DEH-CHO BRIDGE-PIER 3S-RENDERING
AS PER DETAILED DRAWINGS

**APPENDIX B
SUPPORTING DOCUMENTS**

From: Kevin McLeod [Kevin_McLeod@gov.nt.ca]
Sent: Wednesday, August 11, 2010 9:07 AM
To: sdsmith1@telus.blackberry.net; Neil Cumming
Cc: Stuart Smith
Subject: RE: Deh Cho Bridge Phase 1 Audit

Sketch 2 Highlighted area drilled to elev 141.0m and excavated. The remaining area drilled and excavated to elev 142.5m.

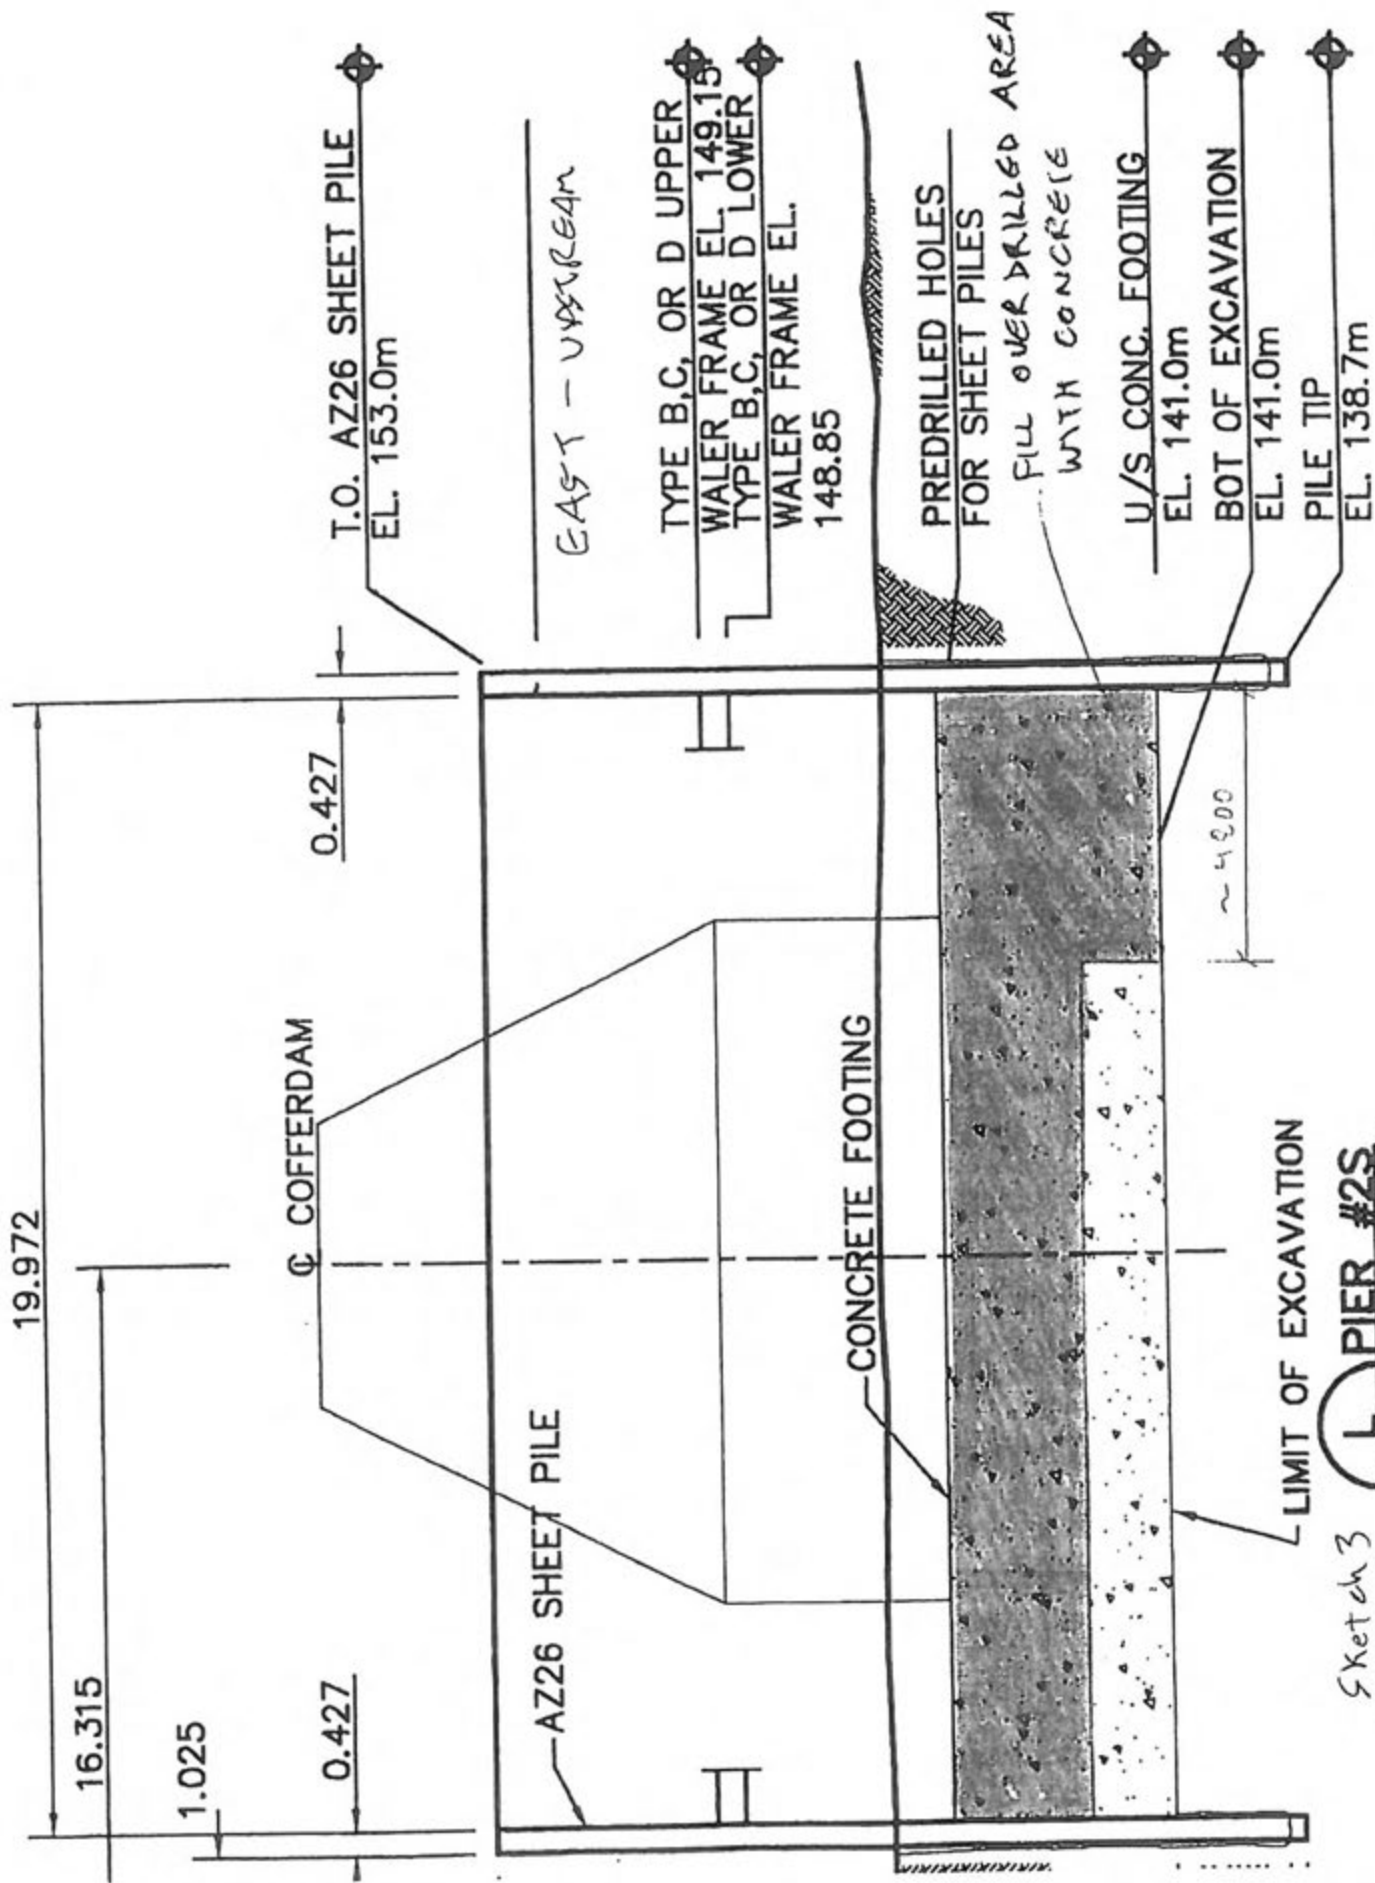
- A Field Change Notice (FCN001) was issued on July 6, 2008 outlining that the footing elevation for pier 2S had been raised 1.5m to elevation 142.5m.
- Prior to getting the Field Change Notice, approximately 25% of the cofferdam floor on the eastern, upstream end of the cofferdam, had been predrilled to the original design elevation of 141.0m (see sketch 1 showing the extent of the overdrilling).

- The remaining portion of the cofferdam floor was predrilled to the revised design as per FCN001 except for the area adjacent to the overdrilled area. This area was predrilled to the original design elevation of 141.0m so that a bench that goes from the north side to the south side of the cofferdam could be excavated (see sketches 1 and 2 showing this).

- Sheet piling was installed around the perimeter of the cofferdam. The sheet piles were driven down to elevation 139.7m on average around the shallower drilled area of the cofferdam (design sheet pile tip elevation in this area is 140.2m). The sheet piles were driven down to elevation 138.7m on average around the deeper drilled area of the cofferdam (design sheet pile tip elevation in this area is 138.7m) (see attached sheet pile as-built information).

- The cofferdam is to be excavated down to elevation 142.5m except for the overdrilled area which is to be excavated to elevation 141.0m. The excavation is to be conducted as per the Ruskin Cofferdam Excavation work procedure submitted previously. The nature of the excavation will create a 1.5m high bench between the two areas. The entire cofferdam floor is to be airlifted to remove any small or loose particles.
- The lower area of the excavation is to be filled with concrete using the Ruskin Tremie Work Procedure. This area is to be filled until it is level with the rest of the cofferdam excavation.
- The reinforcing cage is to be installed into the cofferdam as per the Ruskin Rebar Cage Installation Work Procedure.
- The footing concrete is to be placed as per the Ruskin Tremie Work Procedure.

PIER #2 NORTH LOWER BUTTRESS
NORTH EAST CORNER PROOF OF MINIMUM CONCRETE COVER TO FORMS
CLOSEST POINT OF REINFORCING STEEL TO FORMWORK

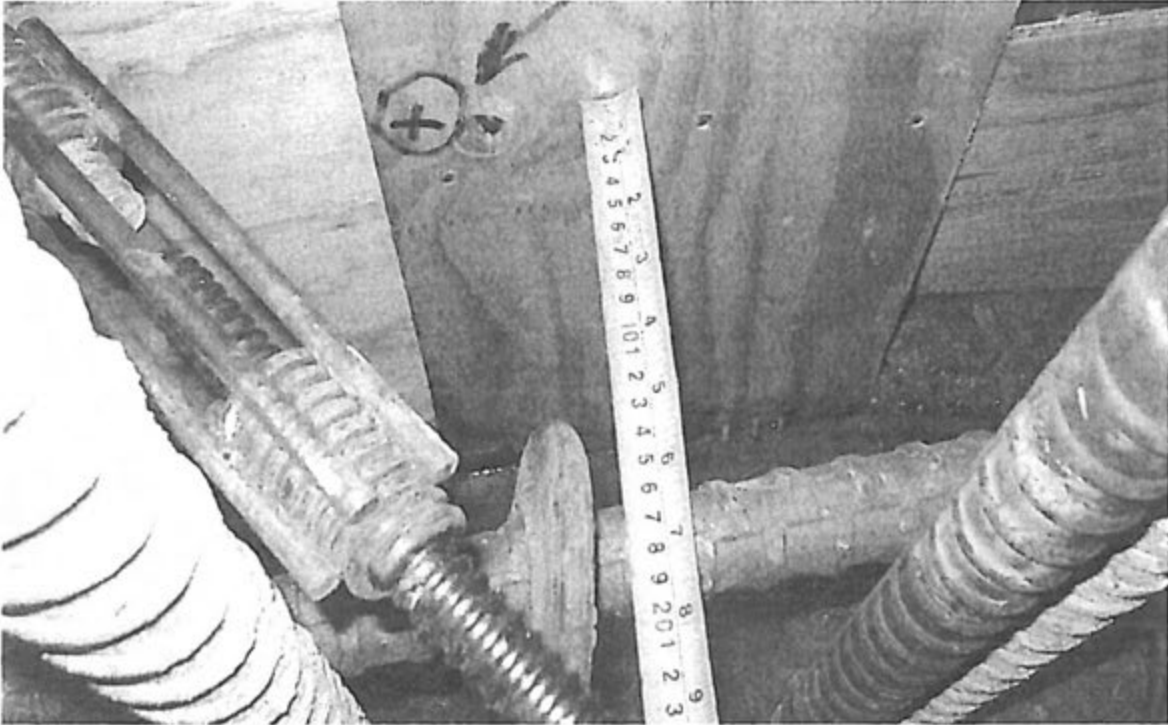
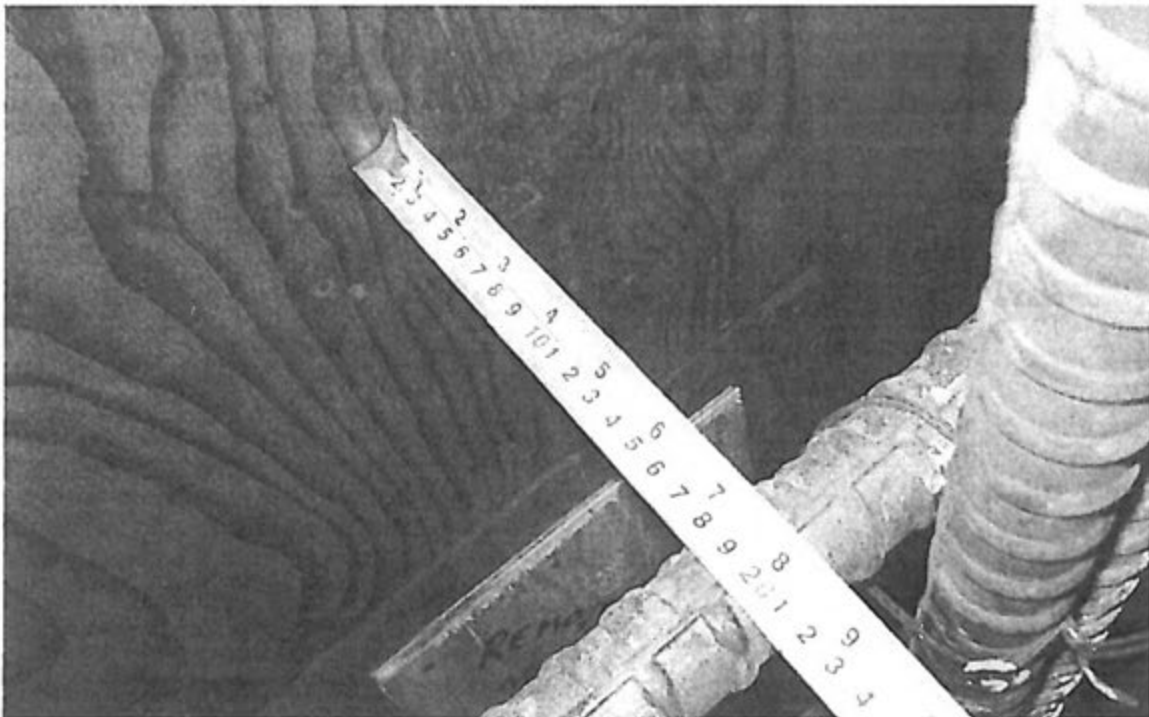
DEH CHO BRIDGE - NON CONFORMANCE REPORT - 009
